RENESAS TECHNICAL UPDATE

Product Category	MPU/MCU		Document No.	TN-SH7-A900A/E	Rev.	1.00
Title	Error correction regarding DMAC interface in RCAN-ET and RCAN-TL		Information Category	Technical Notification		
Applicable Product	See below.	Lot No.	Reference Document	See below.		
		All lots

Figure 21.15 DMAC Transfer Flowchart

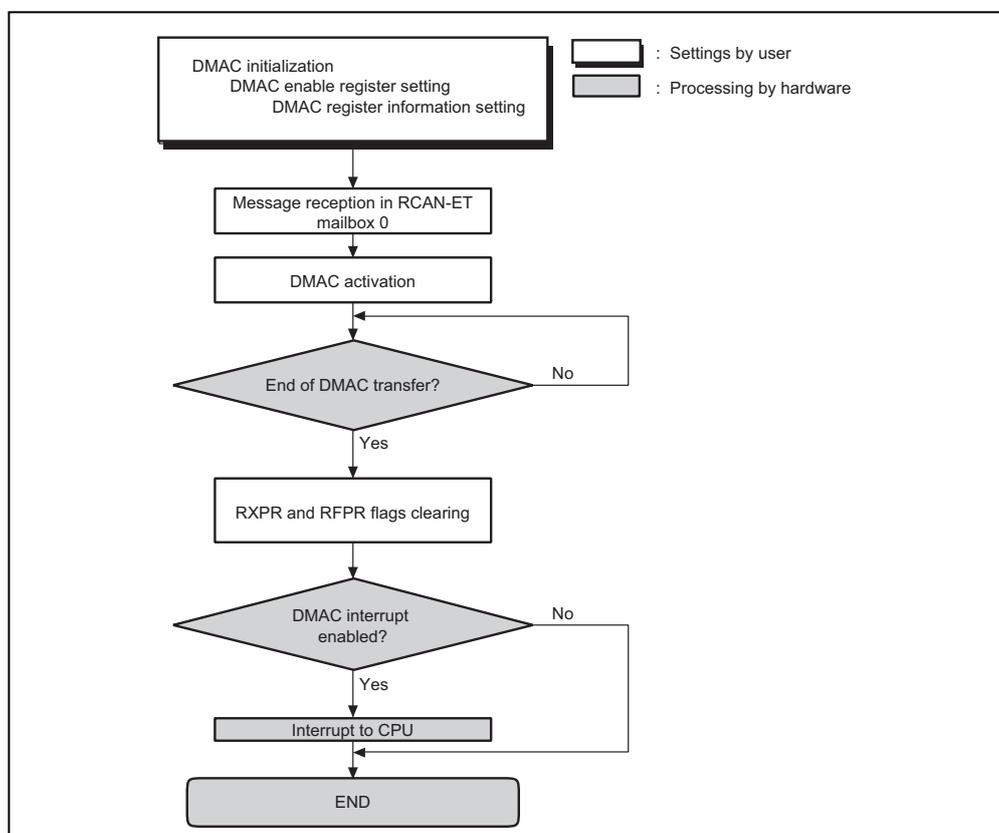
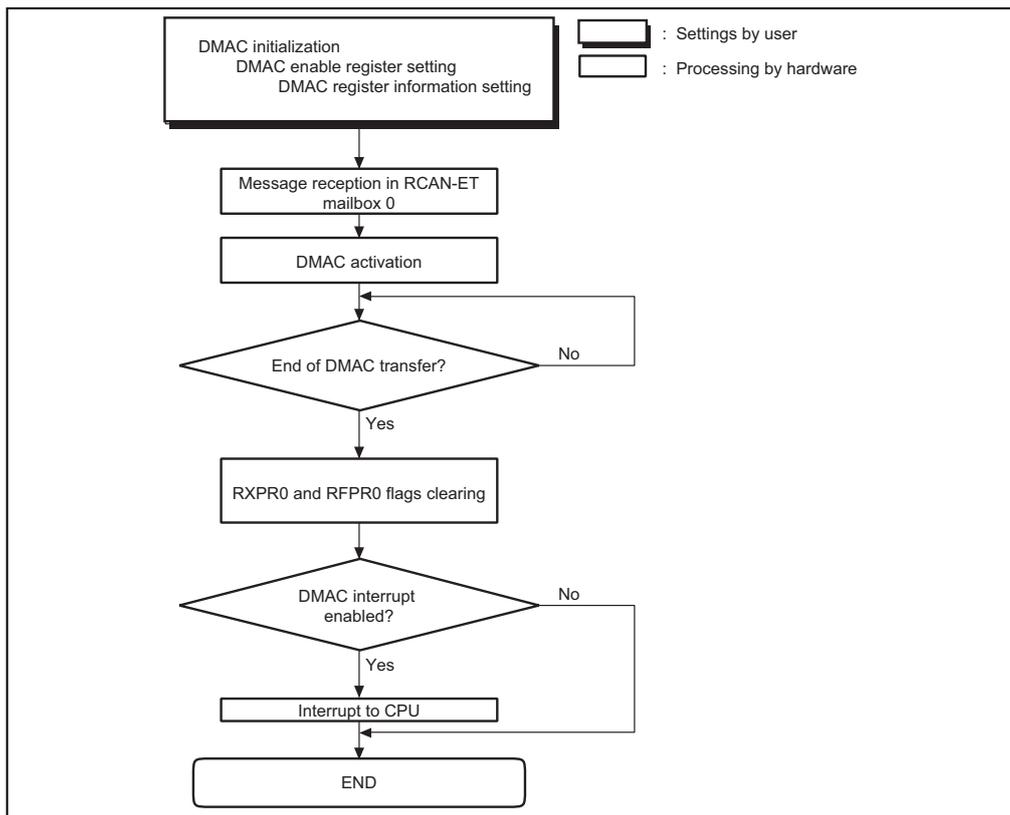
21.7 DMAC Interface

Since hatching is not necessary, it is removed in the flowchart.
